**NOTICE OF COMMENCEMENT OF BENEFICIAL USE**

RE: Request for Approval for Non-Standard Construction of a Well, Well Permit No. 62684-F, Located in the Southeast  $\frac{1}{4}$  of the Northeast  $\frac{1}{4}$ , Section 29 Township 14 South, Range 66 West, 6th P.M., El Paso County

**Request No: 2005-096A**

RE: Fredrick D. Martin Substitute Water Supply Plan  
NE1/4 Sec. 29, T14S, R66W, 6<sup>th</sup> P.M.  
Water Division 2, Water District 10

Planned  
Casing Design  
for  
Permit # 62684F

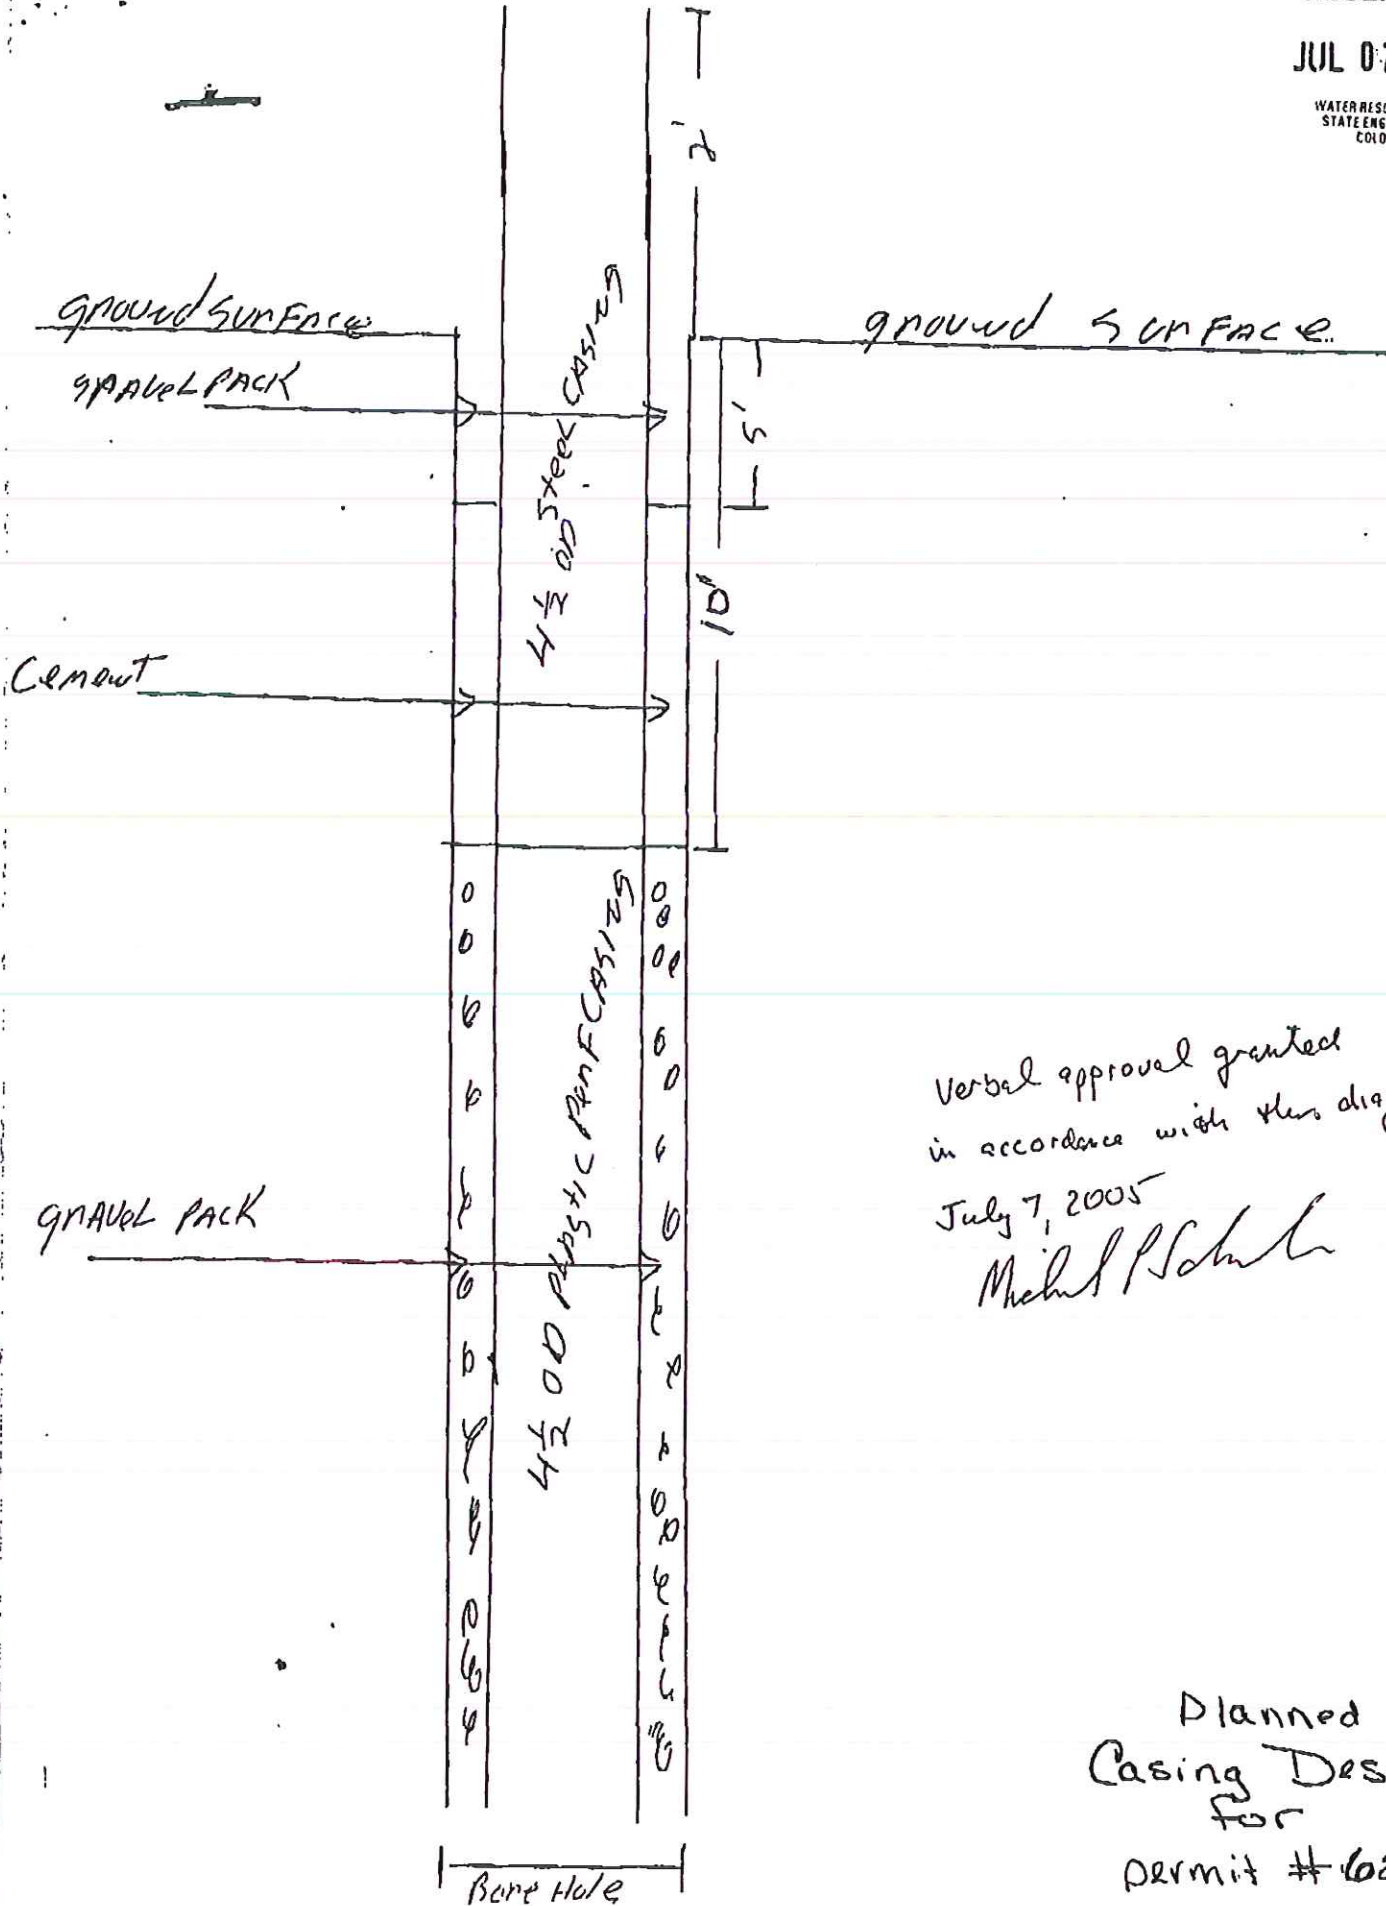
A written request to allow non-standard construction of your well was submitted by your drilling contractor, Kunau Drilling LLC, on July 7, 2005. The request has been reviewed for the Board of Examiners of Water Well Construction and Pump Installation Contractors. The request is specifically for approval to install less than twenty (20) feet of watertight steel casing (Rule 10.4.2/10.4.3) and less than ten (10) feet of continuous cement grout from a depth of at least nineteen (19) feet upward (Rule 10.4.7.1). Verbal approval for the variance was granted to Mr. Kunau on July 7, 2005.

*Emergency Request for a variance  
in the upper steel casing*

1. The well shall be constructed in accordance with the Water Well Construction Rules except as approved by this variance from the Rules.
2. The well shall be constructed in accordance with the diagram submitted on July 7, 2005.

3. Watertight steel casing shall be placed to a depth of at least ten (10) feet below the land surface or to within one foot of the static water level in the well, whichever depth is greater. The steel casing need not exceed a depth of nineteen feet as provided in Rule 10.4.7.1.

4. Cement grout shall be placed in the interval from at least ten (10) feet below the land surface upward to not less than five (5) feet below the surface.

Verbal approval granted  
in accordance with this diagram  
July 7, 2005  
Michael P. Schuler
